Perry Nuclear Power Plant
Docket Nos. 50-440; 50-441
Structural Engineering Branch

Responses to Additional Request for Tunnel Design

FIGURE 19. TRANSVERSE GROUND DISPLACEMENT SPECTRUM (FROM REF. 1)

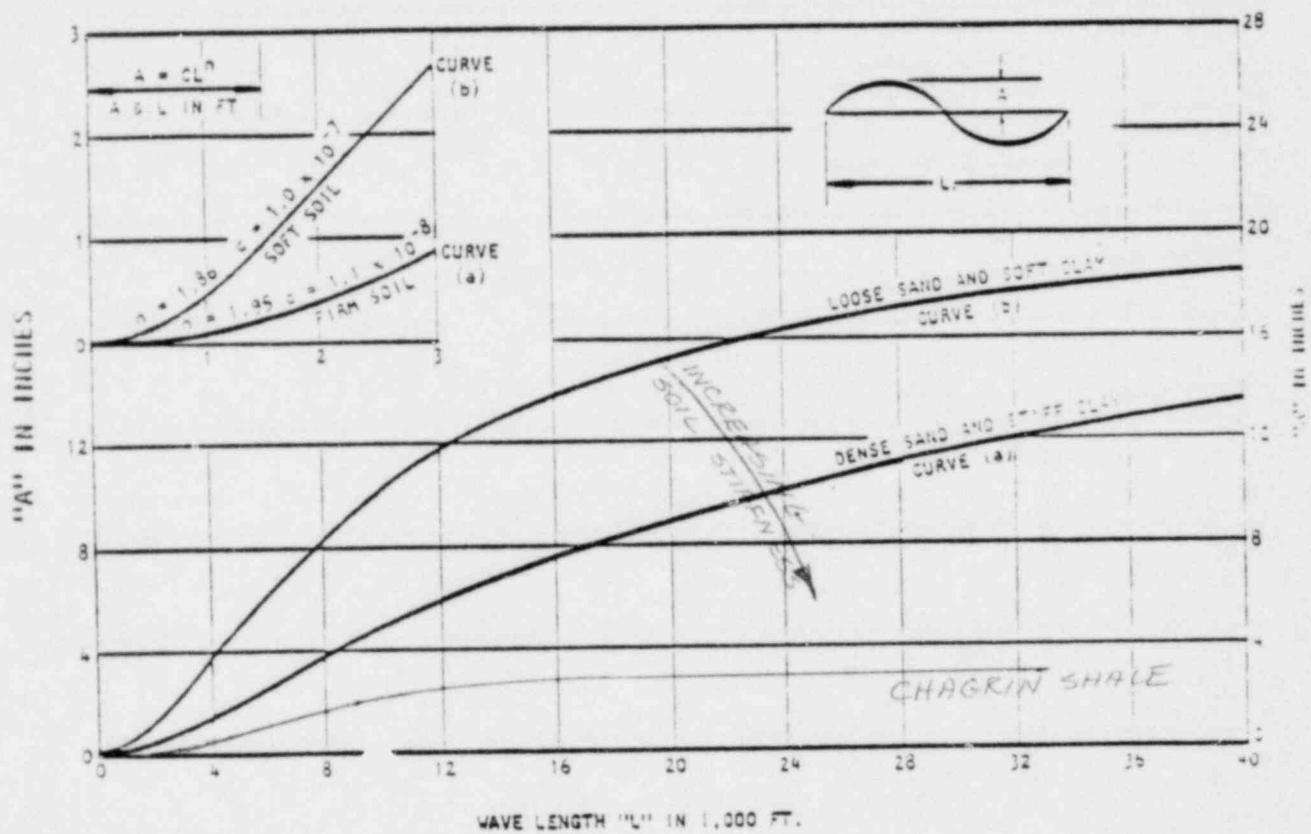
6. Reference page 24 of previous response. What is the basis for the numbers used--especially 9000 feet.

The numbers used to study the response of the tunnel in the longitudinal direction fall out of relationships developed by Kuesel (1969) and the properties of the Chagrin shale. Figure 19, attached herein, shows the relationships between wavelength and amplitude for 1) loose sand and soft clay; and 2) dense sand and stiff clay. I have drawn in the assumed curve for Chagrin shale. The curve was assumed to have the same shape as the curves developed by Kuesel but the magnitude of the wave amplitude is decreased to reflect the stiffness of the shale.

Figure 20 the curve for Chagrin shale only. Basic arithmetic was required to calculate and plot the A/L curve for Chagrin shale. The maximum point on this A/L curve corresponds to 9000 ft wavelength and 19×10^{-6} in./ft amplitude to wavelength ratio. These values were used in the analysis procedure developed by Kuesel.
